Metropolitan Sanitary District
of
Greater Chicago
Tunnel and Reservoir Plan
Special Evaluation Project
Interim Report

U.S. Environmental Protection Agency
Region V
Water Division

March 1988

FIGURE 9 TARP UPPER DES PLAINES MONITORING WELLS

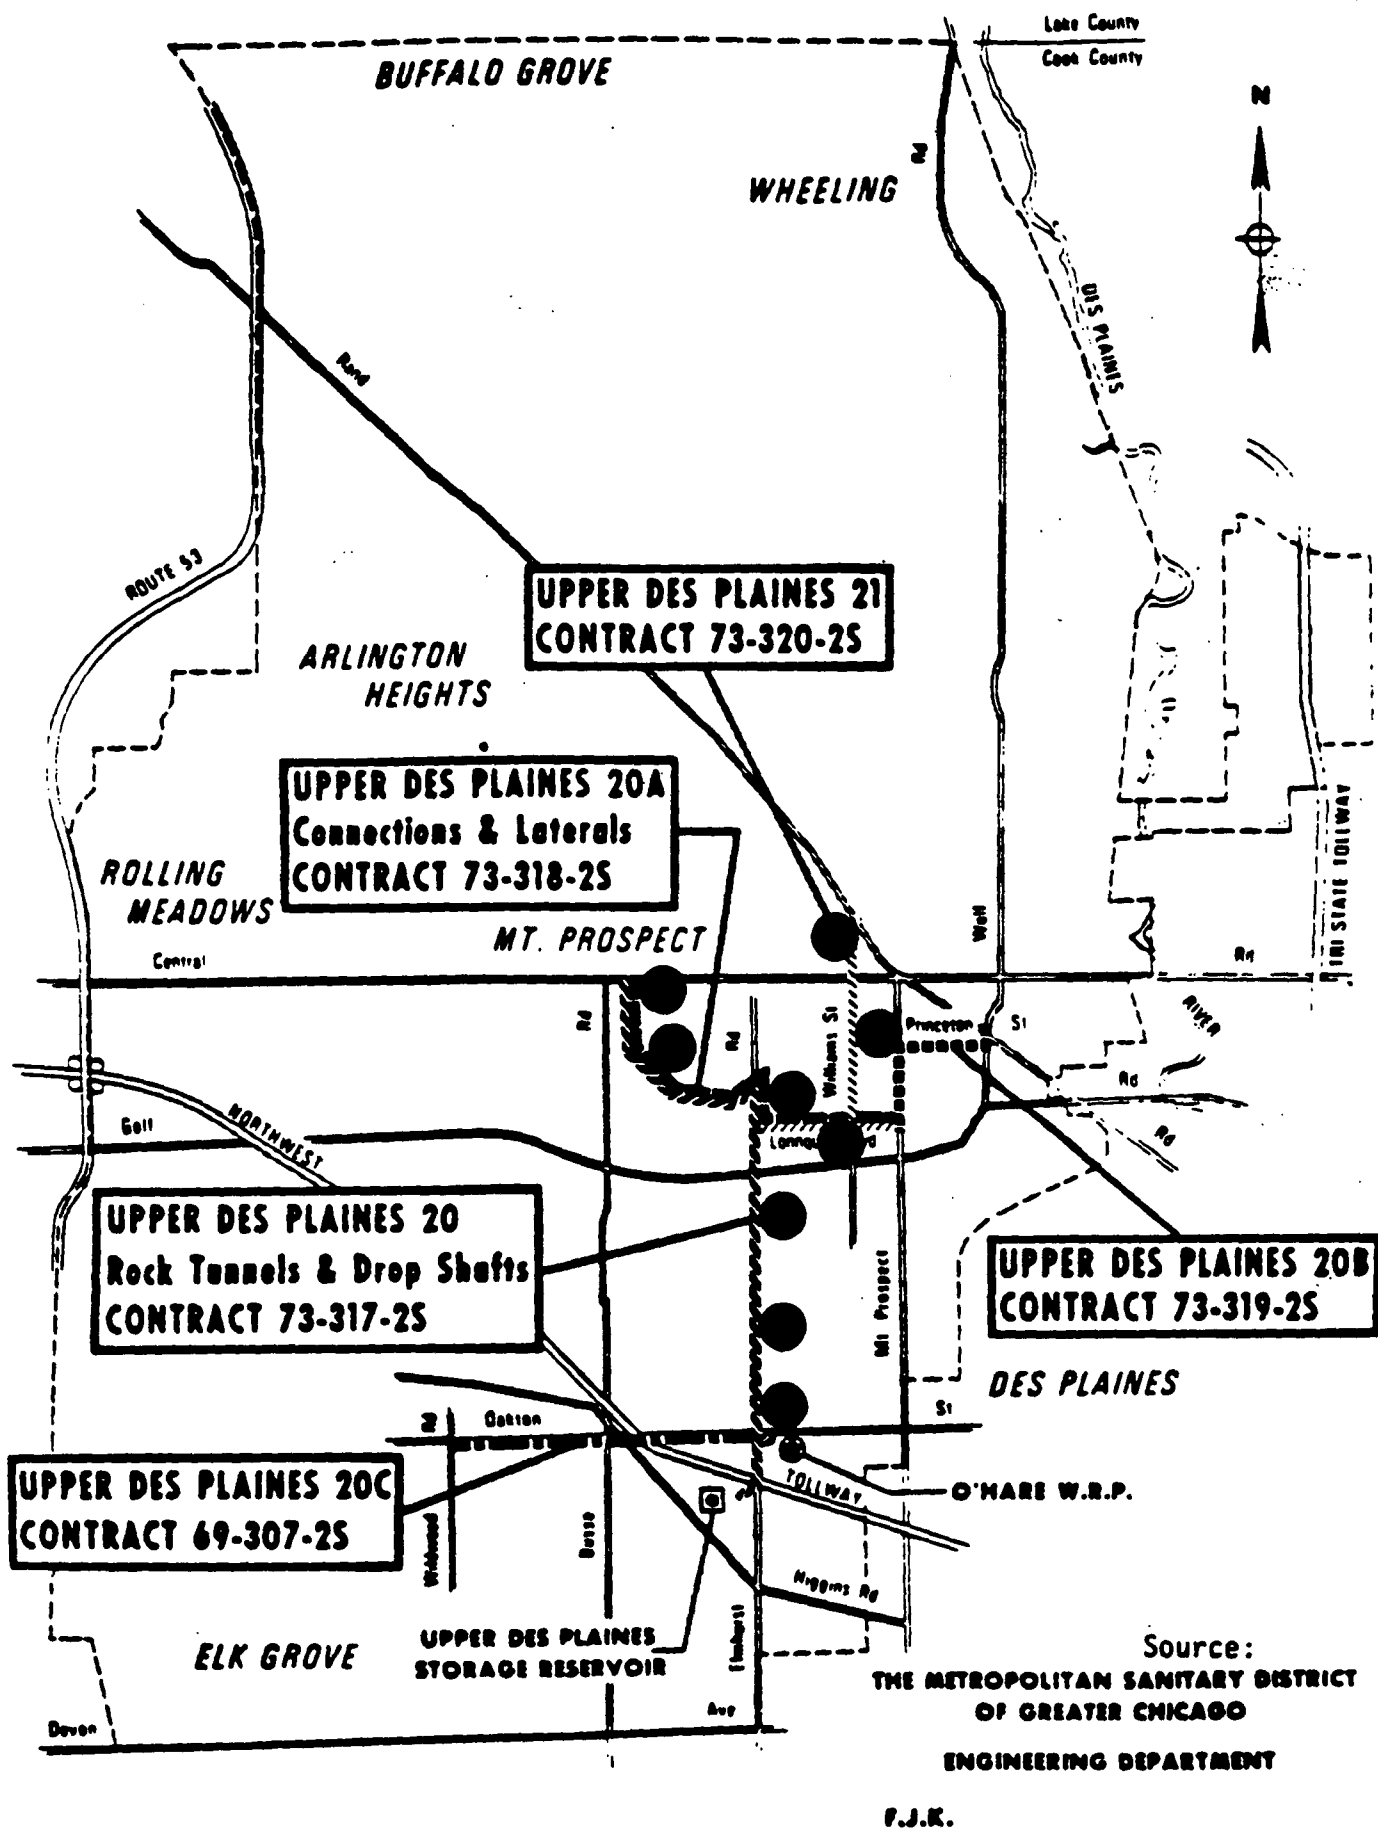
There are nine monitoring wells (See Figure 9) which were sampled bi-weekly from April 1985 to September 1986. Only the raw data were presented to IEPA, with no analysis of results. Upon inspection of the data sets there appeared to be only two sample periods which indicated elevated fecal coliforms. The MW-1 well on the "21" tunnel showed elevated fecal coliforms on October 10, 1985 and August 13-25, 1986. In addition, the water well levels do not appear to have either an upward or downward trend.

If MSDGC can document that the Upper Des Plaines system is operating at full capacity and that potential exfiltration events have occurred, then analysis of continuous level monitoring data for at least well MW-1 of the "21" Section should be performed to evaluate the interconnection between the tunnel and the aquifer. If this analysis shows the tunnel is interconnected, then additional quality sampling based upon this relationship should be performed.

FIGURE 10 TARP CALUMET SYSTEM MONITORING WELLS

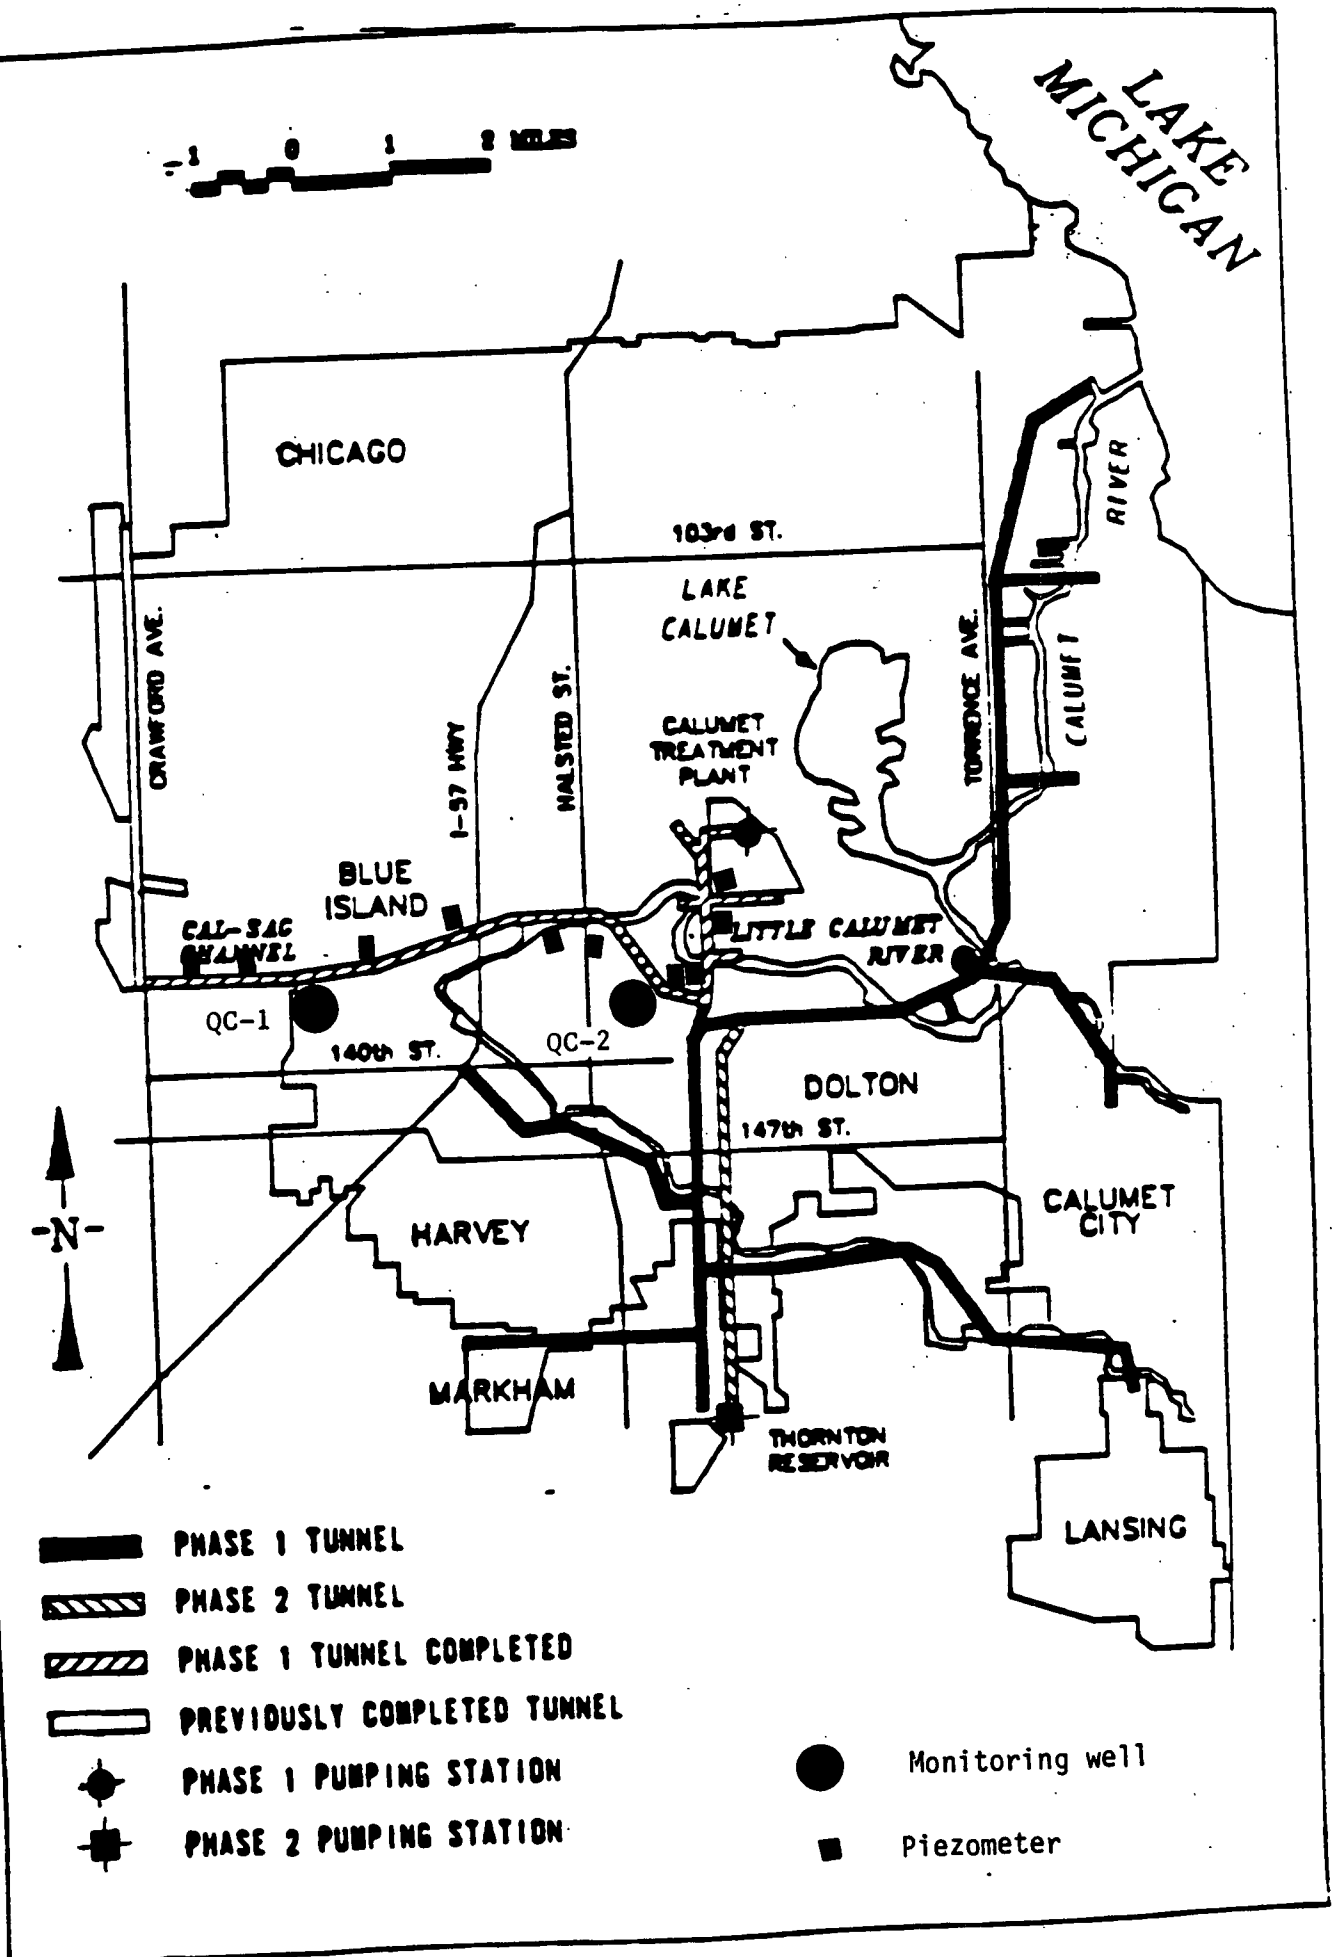
There are two monitoring wells for groundwater quality and eleven monitoring wells for water level measurements. These monitoring well locations are depicted on the map in Figure 10. The sampling frequency was bi-weekly plus additional samples during high water level conditions. The data analysis presented in a November 1986 report was not very extensive and did not attempt to determine if any interrelationships existed between the various parameters evaluated. For example, the report stated there was not a strong correlation between the tunnel water levels and the monitoring well data or groundwater contaminants. However, the two do appear to be related if one uses a lag in the well response. Though the wells are equipped with continuous level recorders, exact lags could not be calculated since well levels were only reported twice a month. See Figure 11 for the correlation. More importantly there is a direct relationship between elevated fecal coliforms and elevated well levels as shown in Figure 12. This was also found to occur during the testing of the tunnel with river water, when elevated fecal coliform levels were detected in a monitoring well after a simulated surcharge condition. In addition, the hardness of the groundwater increased during periods of high water while the alkalinity usually decreased during the same periods. This is circumstantial evidence that water from outside sources is entering the aquifer during these periods, most likely due to exfiltration from the tunnel.

The other wells should be monitoring for water levels to determine if the downward trend will stabilize with time. If this trend continues, at least one of these wells should be sampled for the water quality parameters, especially if the well water level rises after major tunnel water rises.
